# Aquatic Safety Audit Report

Bala North Falls

September 1, 2015

# Aquatic Safety Audit

Highlighting shows location of proposed hydroelectric generating station adjacent to Bala North Falls

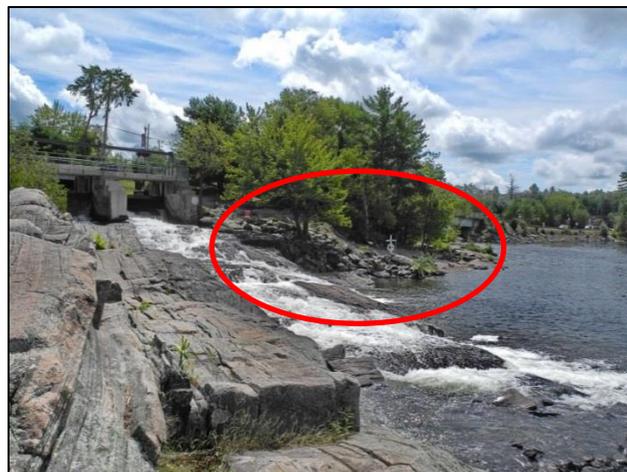
The Bala Falls North dam is located at the top of the Bala North Falls and is the historic natural outlet from Lake Muskoka. It is within the downtown business district of Bala. The proposed hydroelectric generating station would be installed adjacent the current north falls dam, along the south shore of the Bala north falls (see approximate location as highlighted in the photograph below).

The proposed station's intake and tailrace would be significantly closer to this known and long-time swimming, wading, boating, and public and private docks. The result is this proposed generating station would put bathers and boaters at risk.

Proposed flow conditions in the area of the North Bala Falls

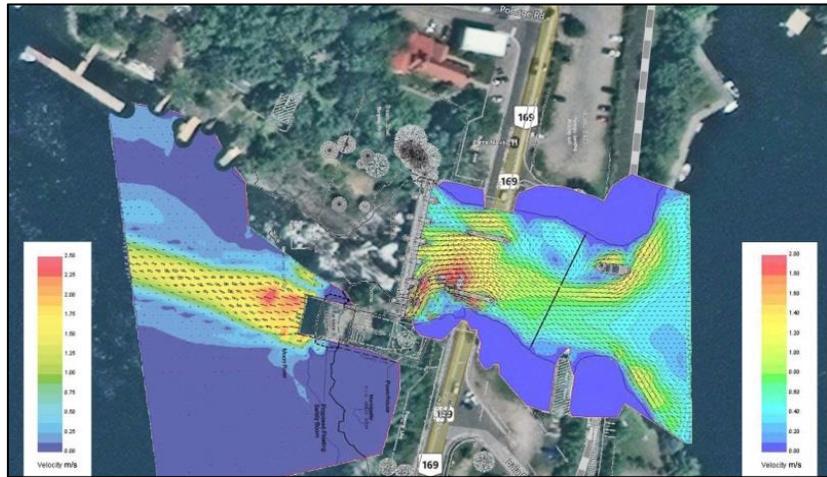
These areas of a generating station are not intended for bathing, wading or boating, and would be extremely dangerous.

To ensure the public cannot access these areas steps should be taken to prevent their access. One possible solution to restrict the public from bathing or wading in this area would be to install a series of fenced walkways and observation decks surrounding the Bala North Falls. This would permit safe viewing of the Bala North Falls. Such fencing has been successful at Bracebridge Falls.

- Nearby public and private docks, both upstream and downstream, for which fencing would not be possible.
- Multiple land owners, portaging, scuba diving, and many boating activities both upstream and downstream, all of which create many other means of access.
- No breakwater, such as that at the Bracebridge Falls generating station which directs the tailrace discharge water away from the in-water recreational area.
